Comments on NRC Draft Screening Criteria for Assessing Potential Seismic Vulnerabilities of Spent Fuel Pools at Decommissioning Plants – December 3, 1999 NRC Memorandum

Preliminary Industry Comments

Figure 1

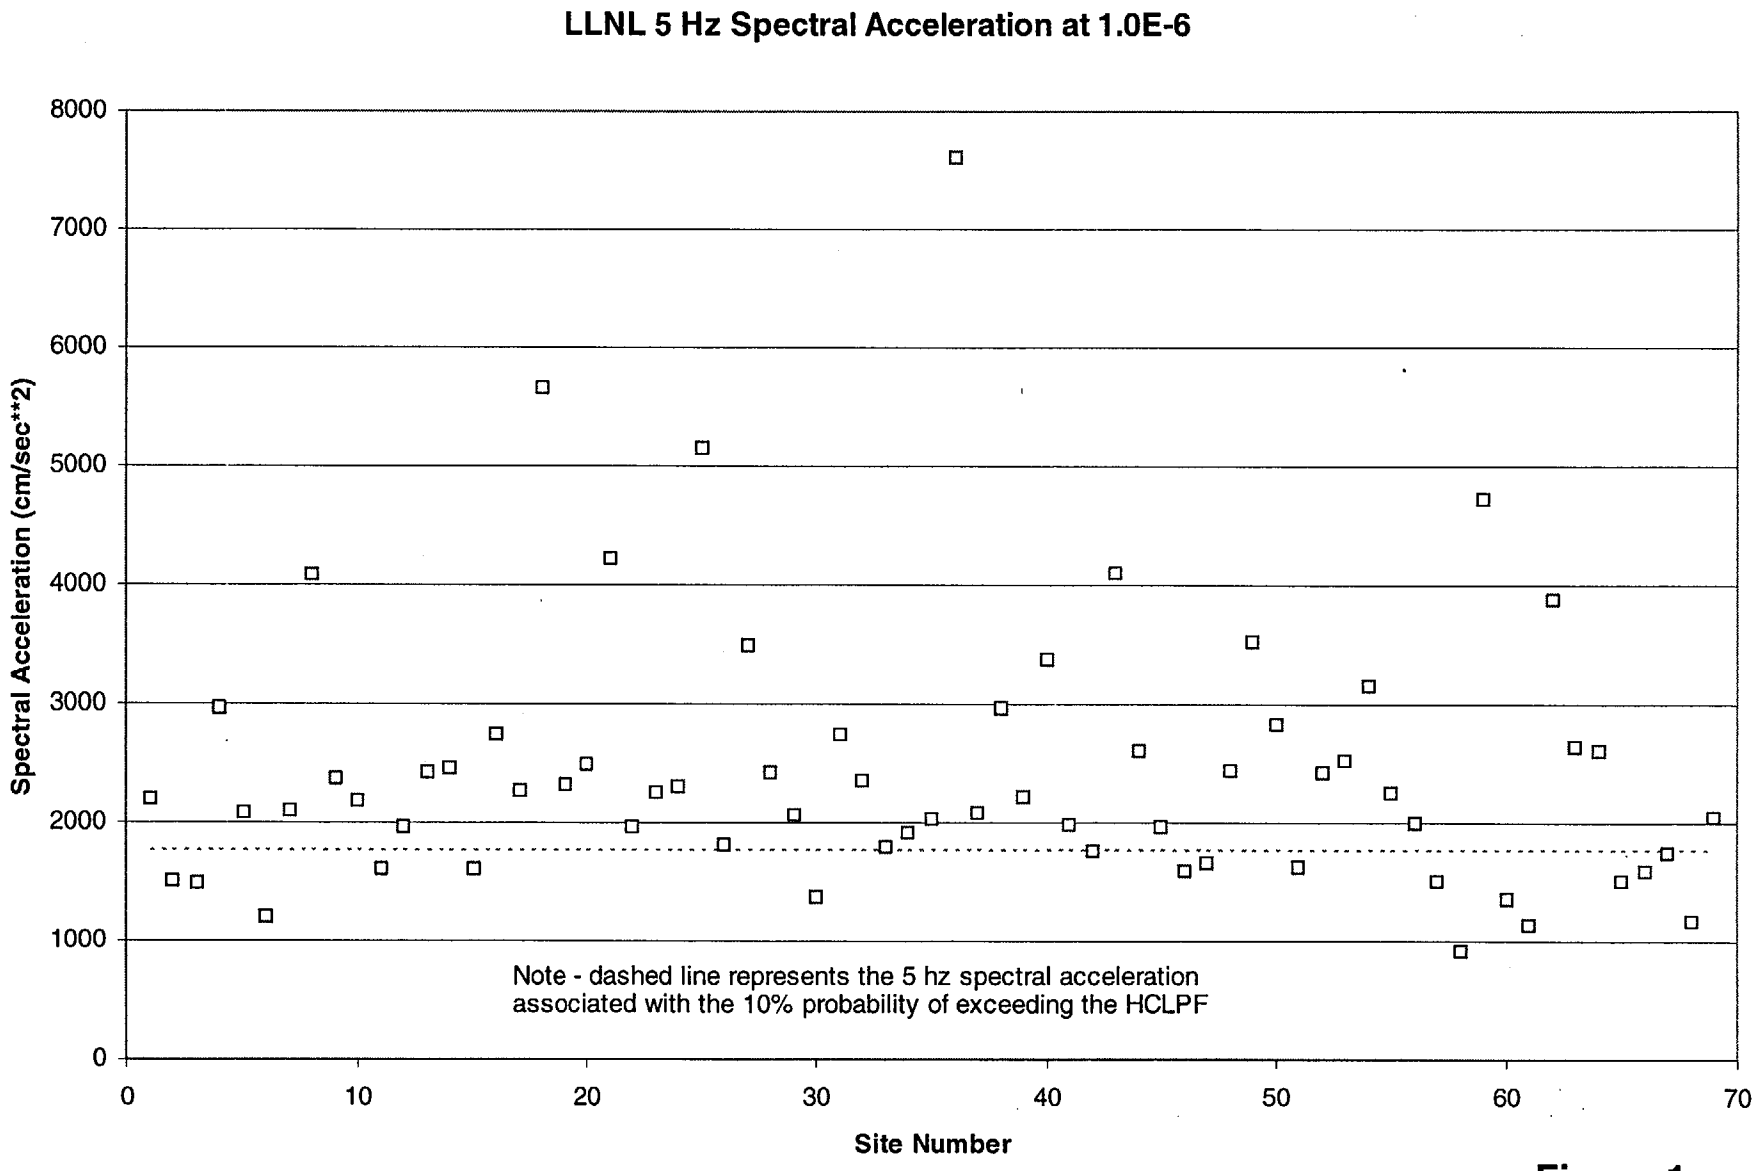
5. For a site to be screened out the $C_{10\%}$ value should be on the order of 10^{-6}. Figure 1 (attached) shows the 5 Hz spectral acceleration values associated with the 10^{-6} LLNL results at each of the 69 sites. As can be seen, for site number 36 (which in Table 3 of the Kennedy report is the site with the highest SFP failure frequency) the 10^{-6} spectral acceleration is about 7,700 cm/sec^2 or about 245 cm/sec. As stated previously, 57 cm/sec is consistent with 5 Hz spectral velocities associated with a magnitude 6.6 earthquake 8 km from the site (San Onofre SSE), therefore these predicted groundmotions must be associated with a very large earthquake, greater than magnitude 6.5, very near to the site – which is counter to the conclusions of SECY-91-135. Other values at other sites are equally incredible. Based on these results, it is concluded that the LLNL results, at the probability/ground motion levels of interest, are deterministically incredible and therefore their use in screening is questionable. Figure 2 (attached) shows the 5 Hz spectral acceleration values associated with the 10^{-6} EPRI results. As can be seen, the EPRI

Figure 2

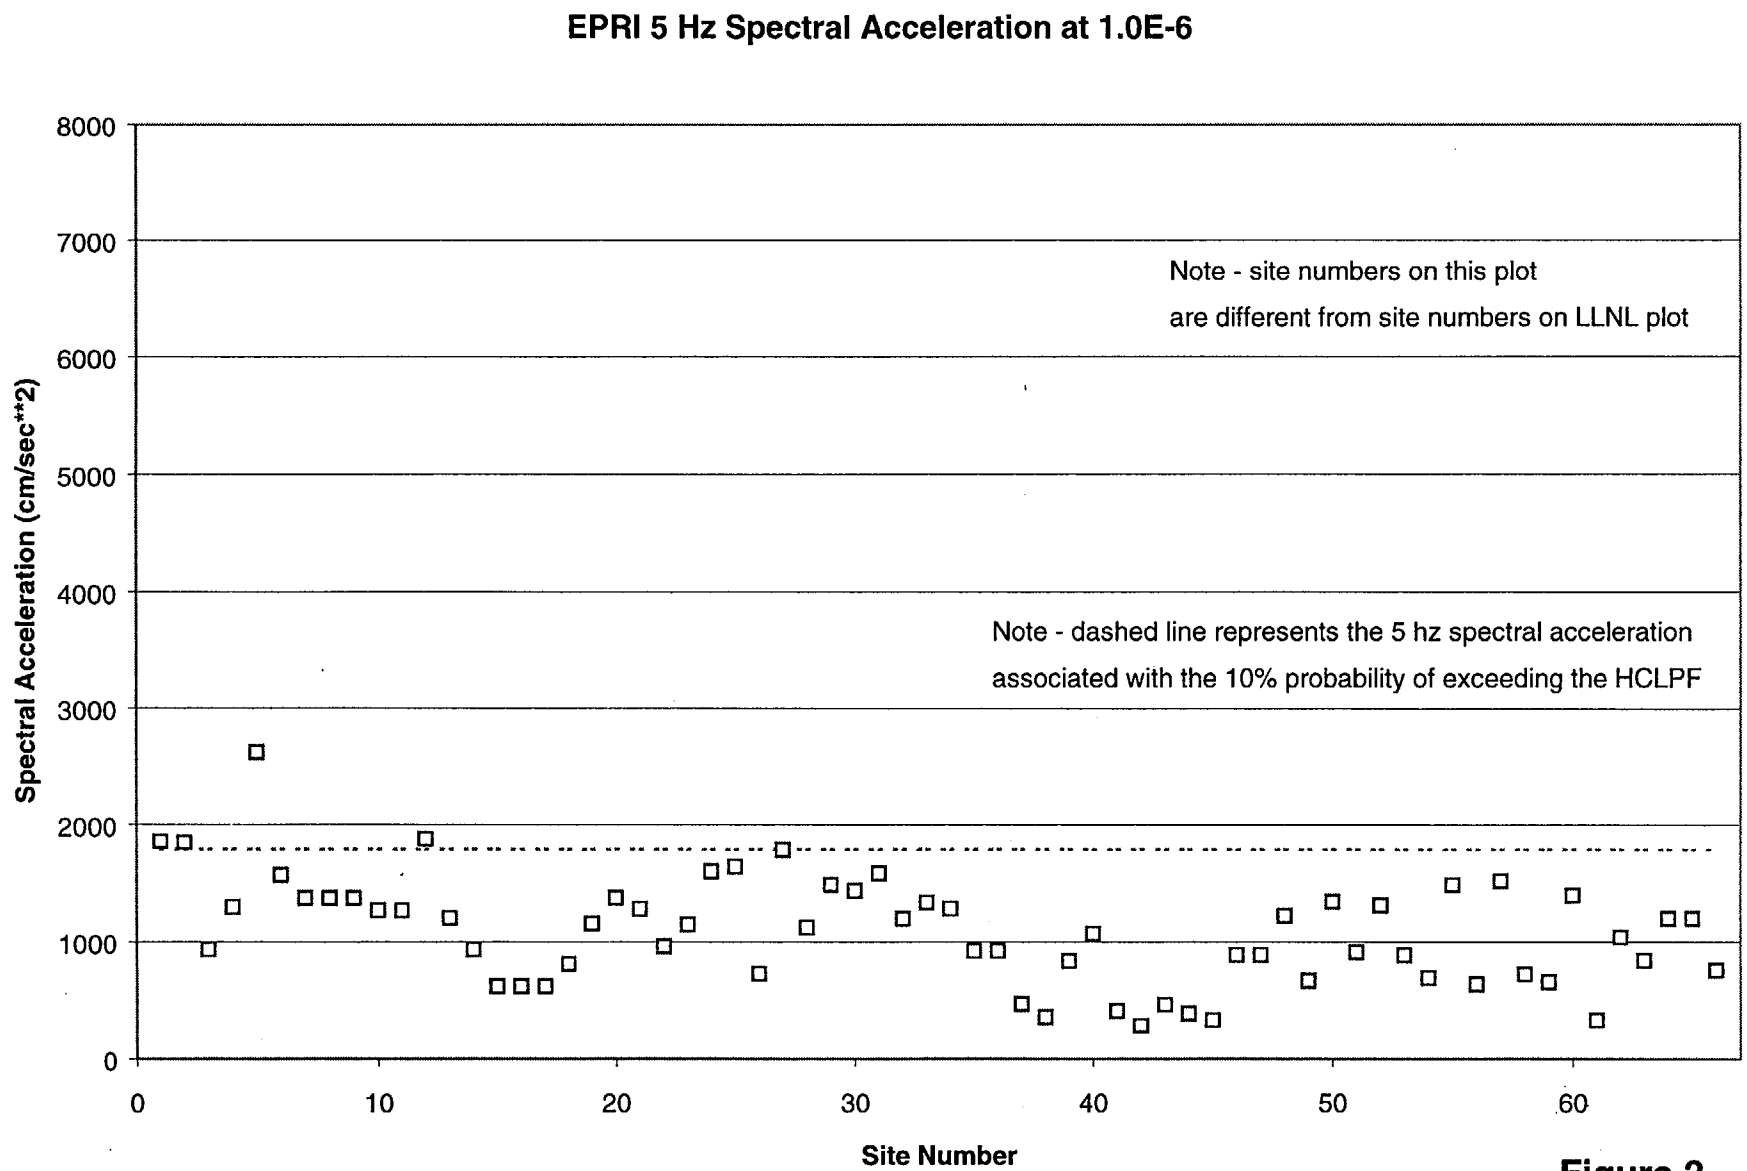
results, at the probability/ground motion levels of interest, are credible, and consistent with SECY-91-135.

Figure 3

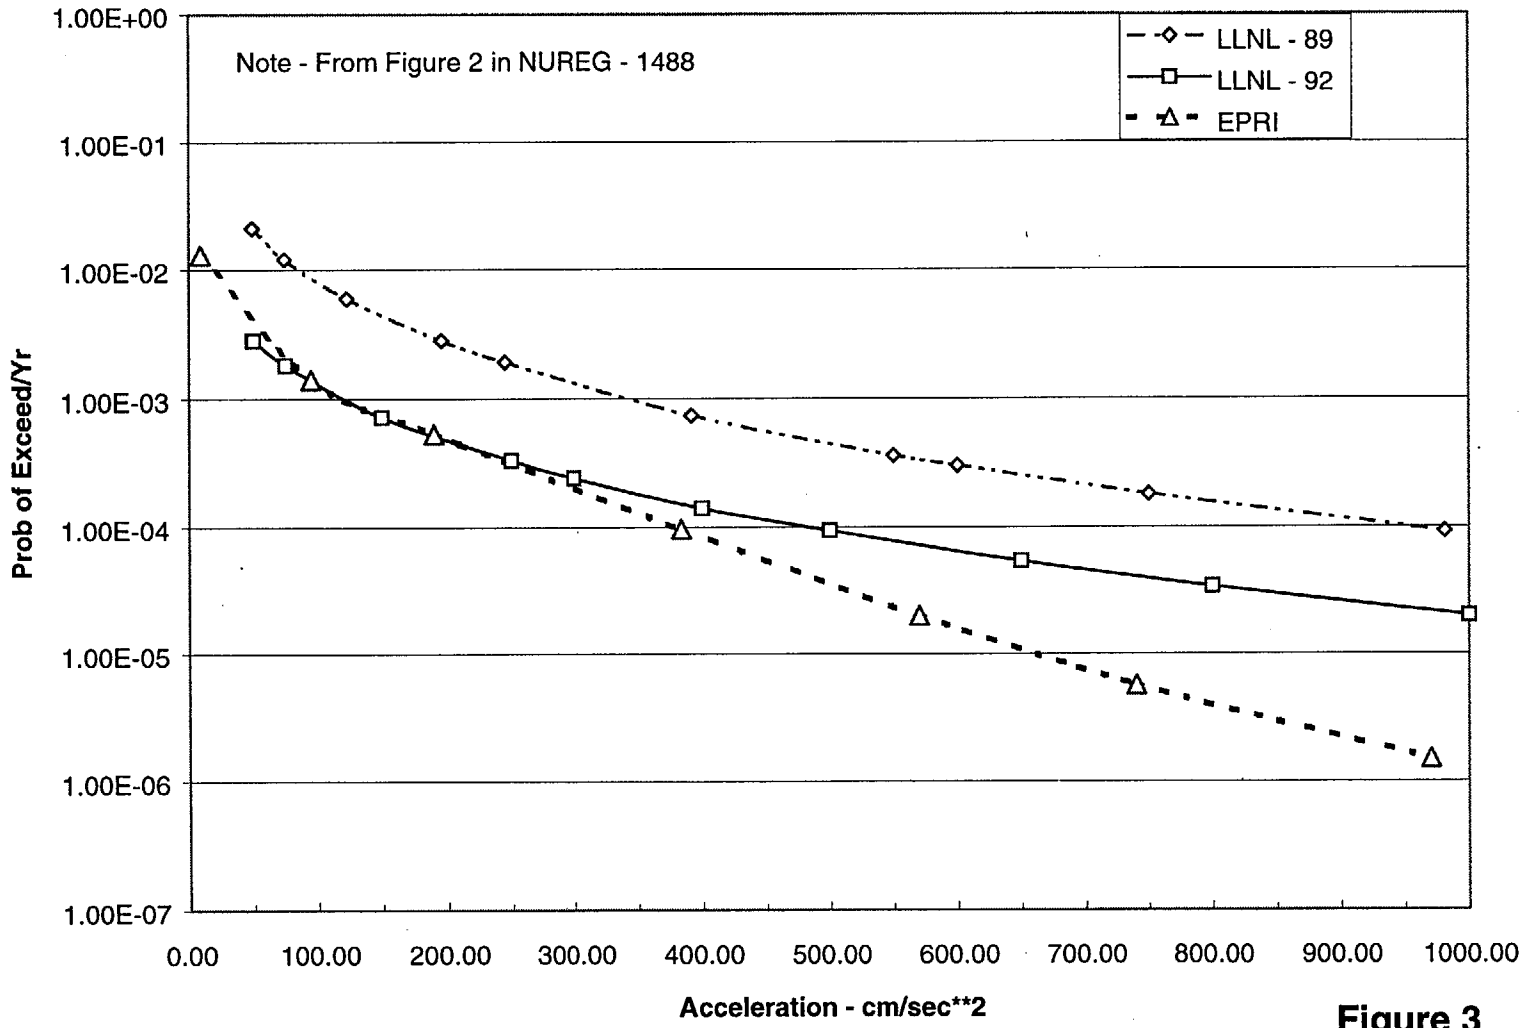
5. Figure 3 (Figure 2 from NUREG-1488, Reference 5) illustrates the problems associated with the LLNL results at high ground motions/low annual probabilities. As can be seen from Figure 3, at high probabilities there is reasonable agreement between LLNL and EPRI. However, the slope of the LLNL results at high ground motions is too shallow. The effect of this shallow slope is to predict incredible ground motions at credible probability levels.

6. Based on this review, industry contends that it would be appropriate to only use EPRI results in the SFP seismic screening analysis. We believe this to be reasonable in light of the difficulties associated with the LLNL results at low probabilities. The effect of using only the EPRI results is shown in column 3 of Table 3 in the Kennedy report (Reference 1). As can be seen, only 1 plant would be required to perform further analyses. However, because both LLNL and EPRI are considered to provide valid results, it is proposed that the results from each study be geometrically averaged such that equal weight is provided the results from each study. Arithmetic averaging is considered unacceptable in light of the difficulties associated with the LLNL results. Figure 4 provides the results of geometrically averaging the LLNL and EPRI results.

Figure 4

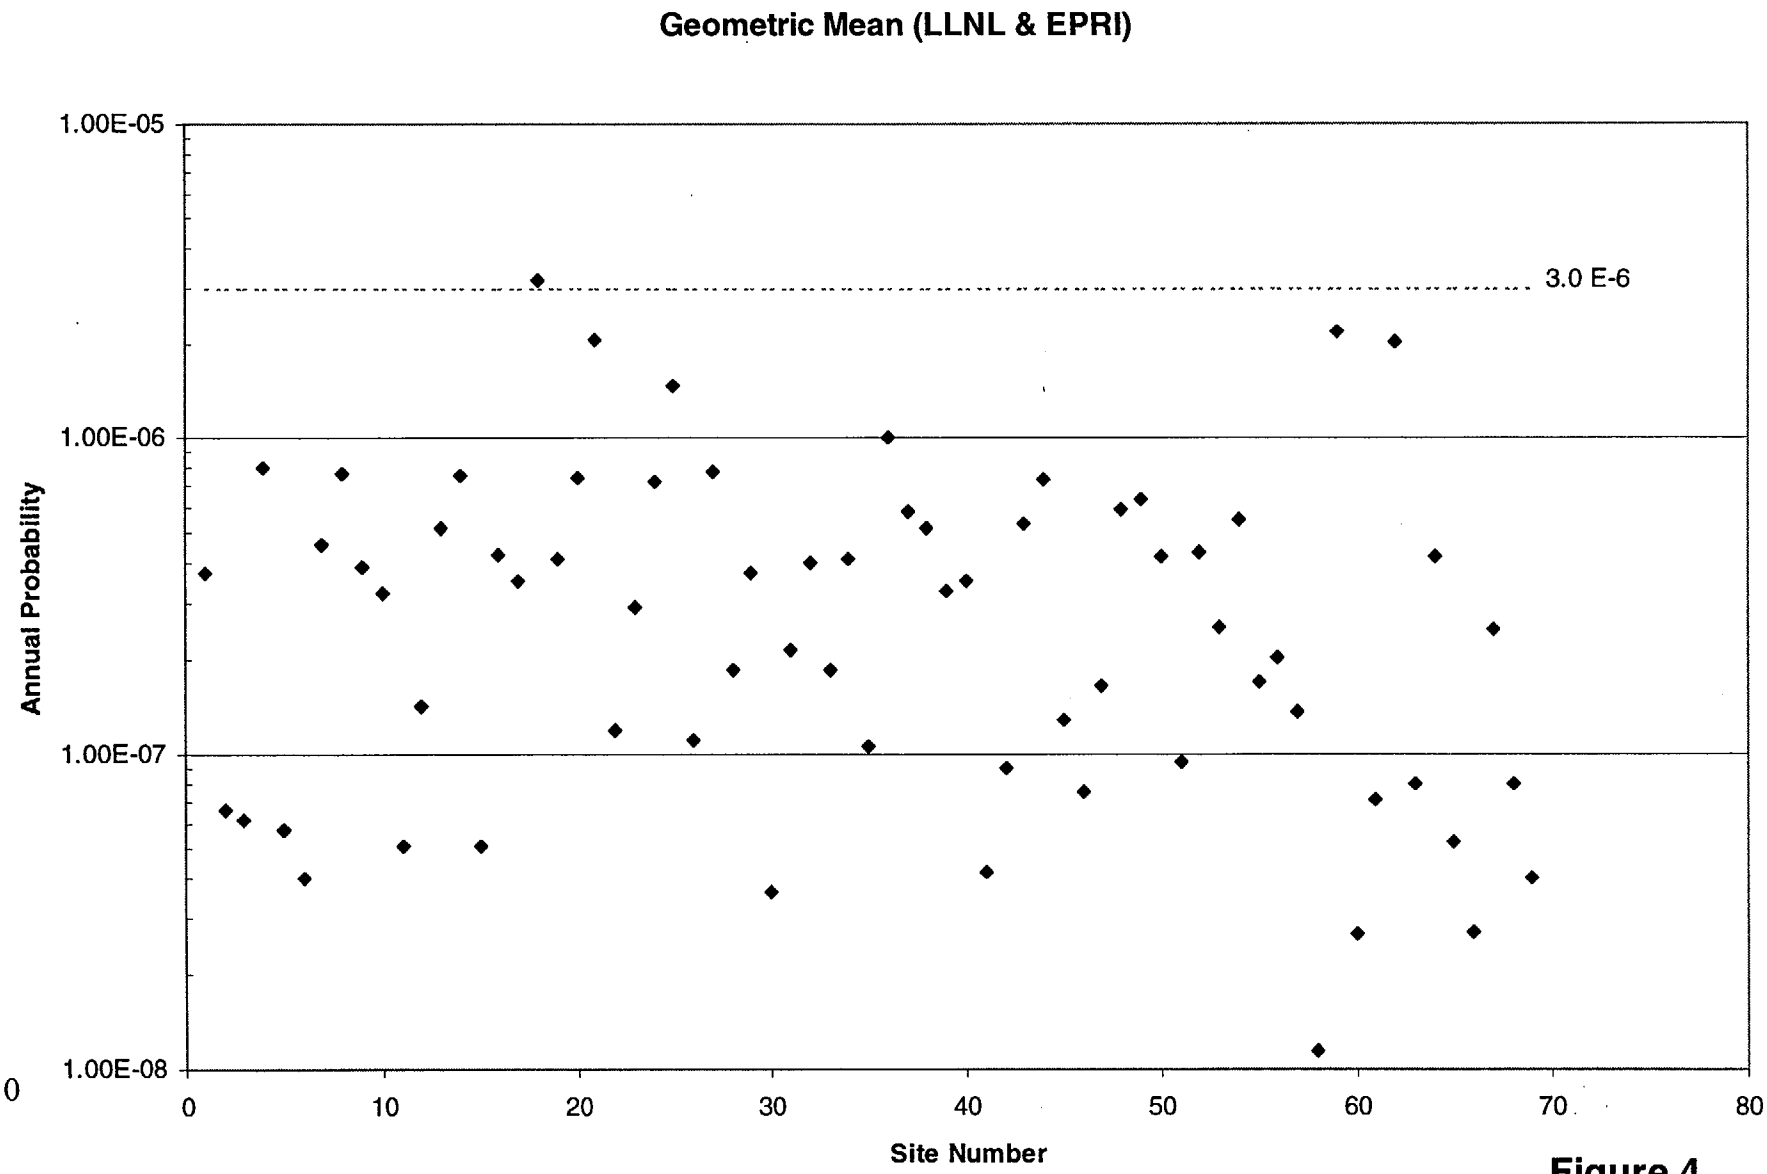
Based on Figure 4 about 6 sites would be preliminarily screened in due to exceeding the 10^{-6} criterion. One of the 6 sites is Shoreham. If these screened in SFPs are above ground then further analyses will be required.
